## 5.2 Integrity of Reactor Coolant Pressure Boundary

The information in this section of the reference ABWR DCD, including all subsections, tables, and figures, is incorporated by reference with the following departures and supplements.

Figure 5.2-2 MSIV Closure with Flux scram and Installed Safety / Relief Valve Capacity

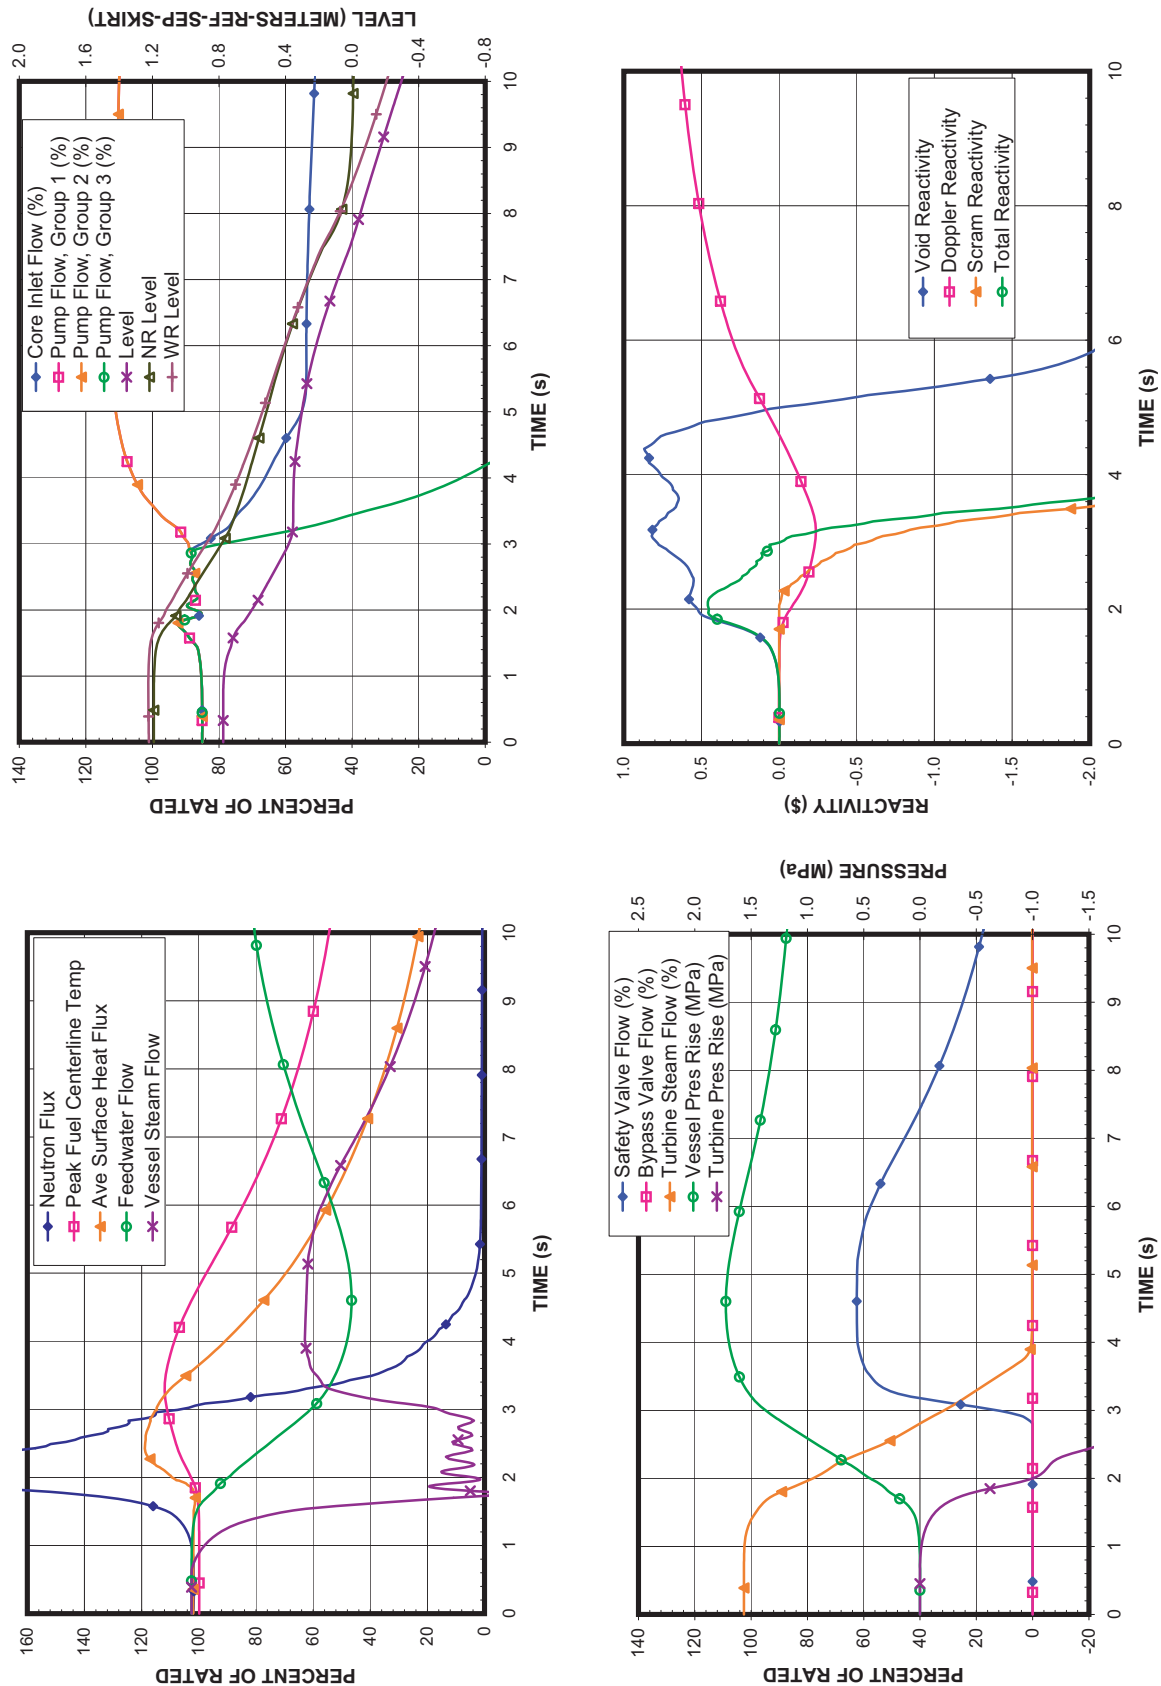
STD DEP T1 2.1-1 (Table 5.2-3, Figure 5.2-2, replaced entire figure)

STD DEP T1 2.1-1

The required SRV capacity is determined by analyzing the pressure rise from an MSIV closure with a flux scram transient. Results of this analysis are given in Figure 5.2-2. The peak vessel bottom pressure calculated is ~~8.79~~ 9.09 MPaG, which is well below the acceptance limit of 9.48 MPaG. The results show that only 12 valves are required to meet the design requirement with adequate margin. The analysis assumes one of the 12 SRVs fails on demand.
